INTERIM REPORT OF THE DOE TYPE B INVESTIGATION GROUP

Appendix D

LICENSING CORRESPONDENCE

JULY 1990

Figure 4

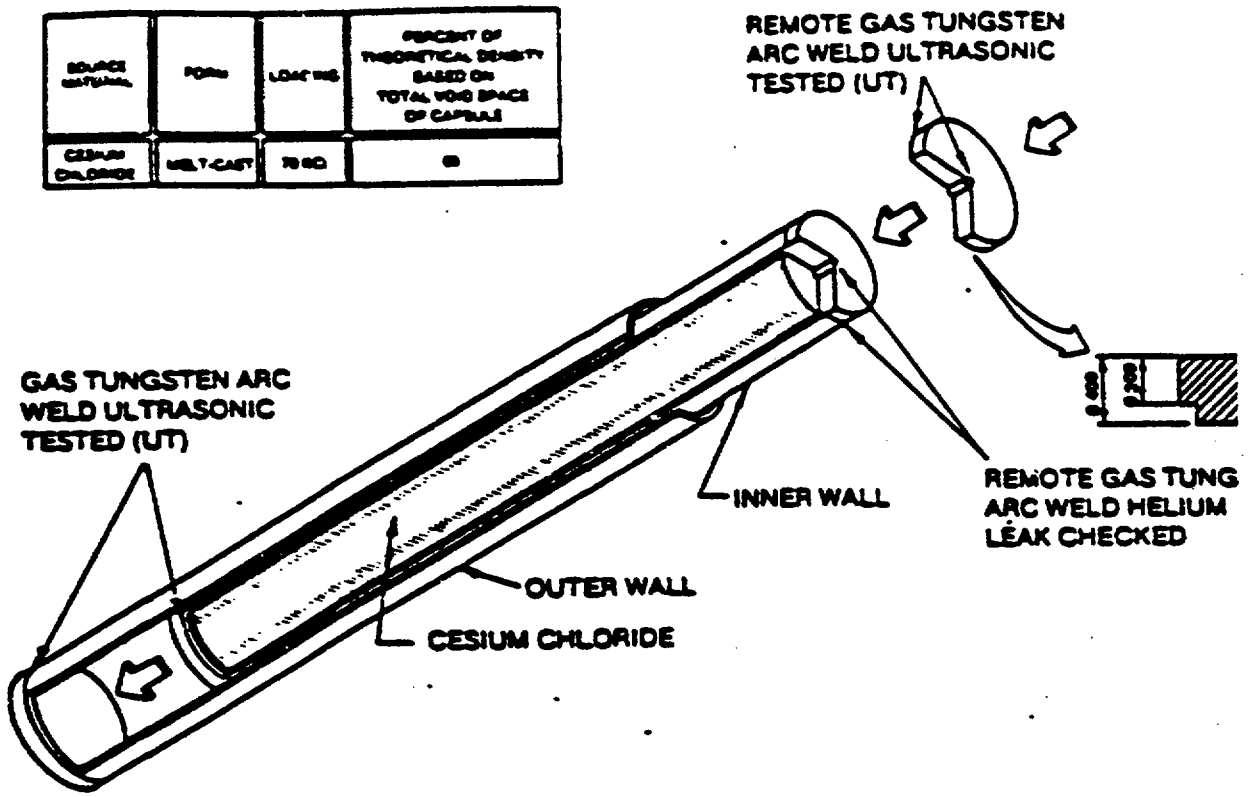
The cesium source elements will be the WESF capsules produced by the DOE at Richland, WA. A drawing of the WESF capsule is included for reference. Each source will be serialized for identification by the supplier.

FIG. A-1

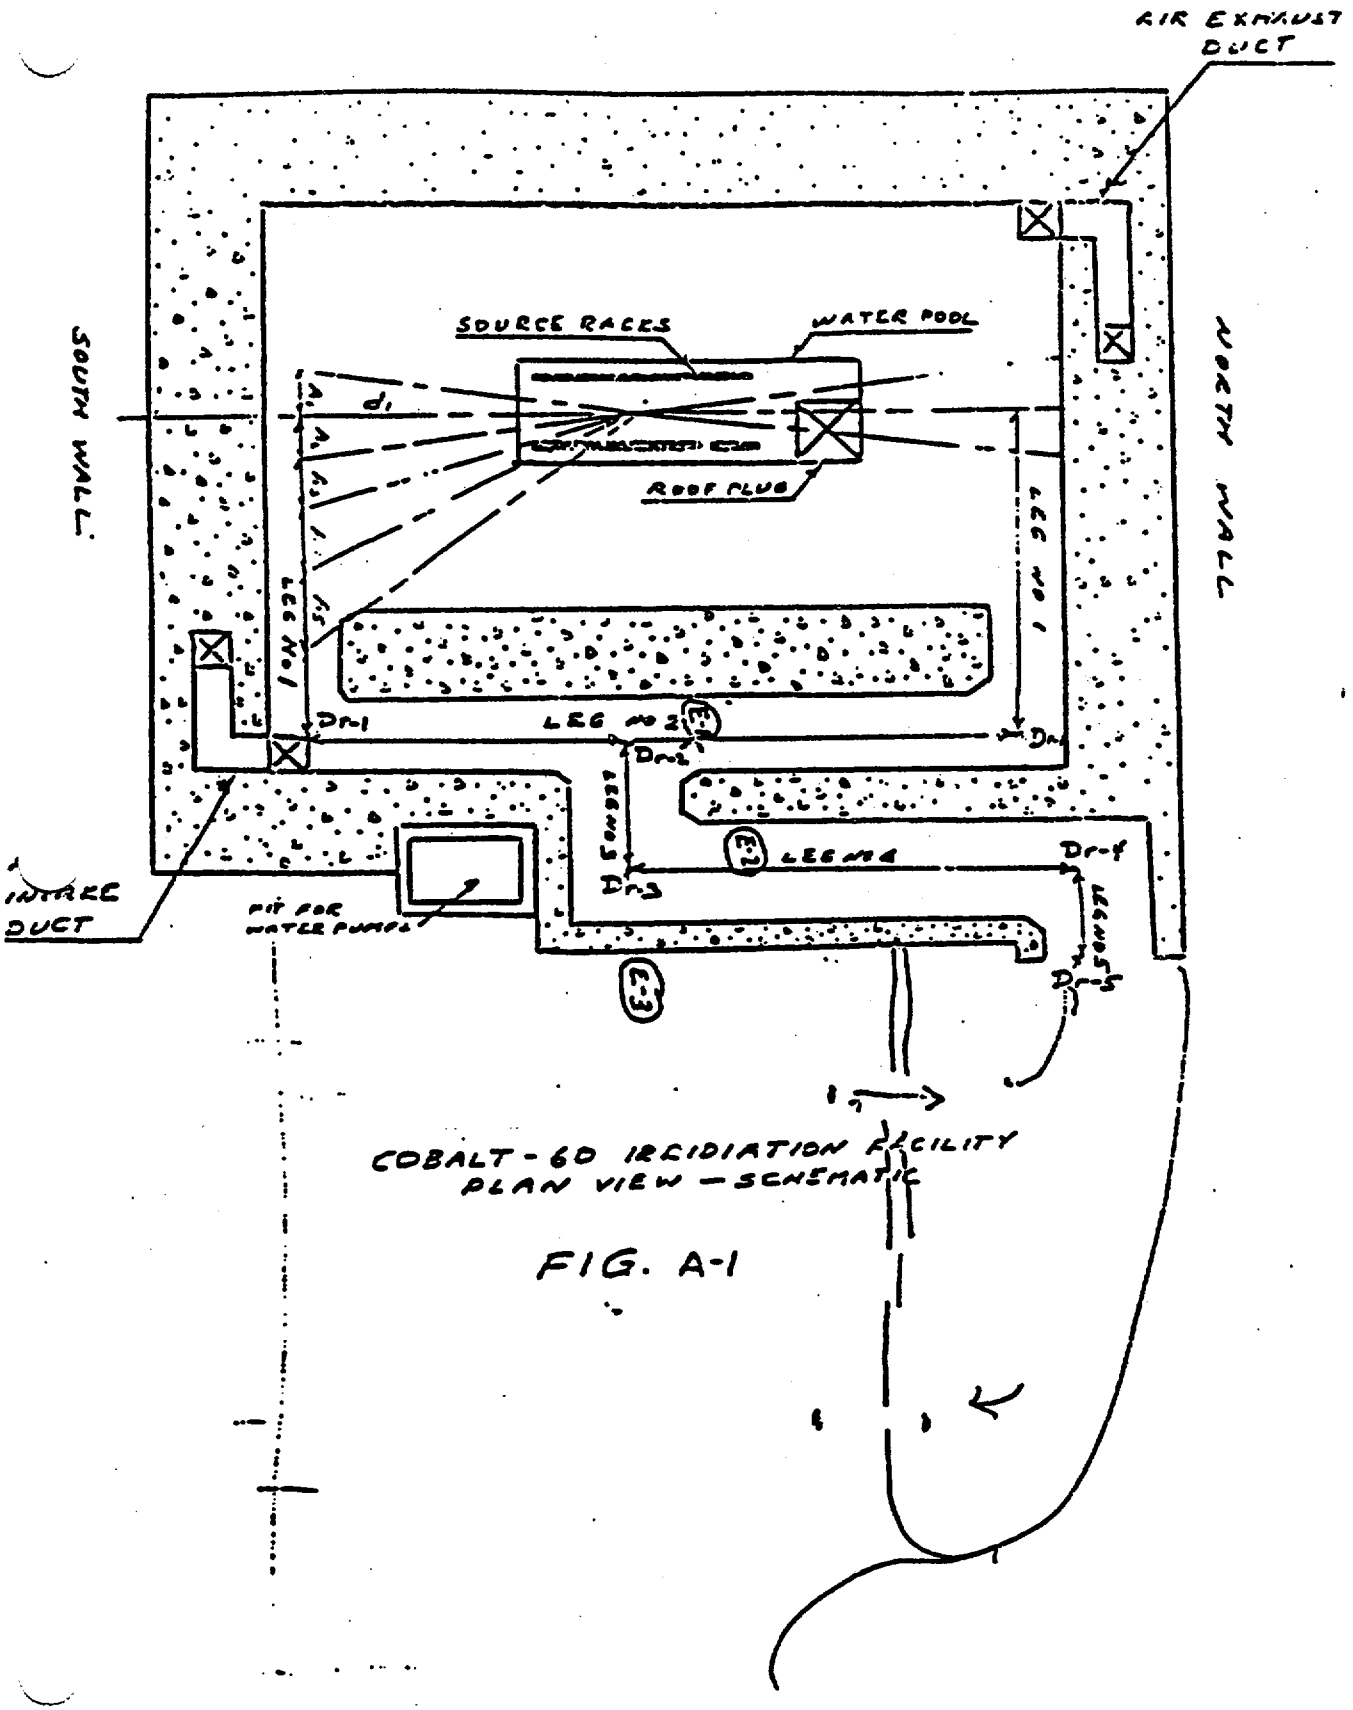
The exposure rate of 42.1 mR/hr behind the east maze wall is located within leg 2 at point E-1. At locations E-2 and E-3 the leakage dose rates are reduced to 0.0014 mR/hr and 0.11 mR/hr respectively. Refer to Figure A-1.

Figure 6 from NCRP 51, page 62, demonstrates how to set up path lengths within a maze containing 5 legs, for a collimated x-ray or gamma source. Figure A-1 shows radiation legs 1 through 5 within the maze.
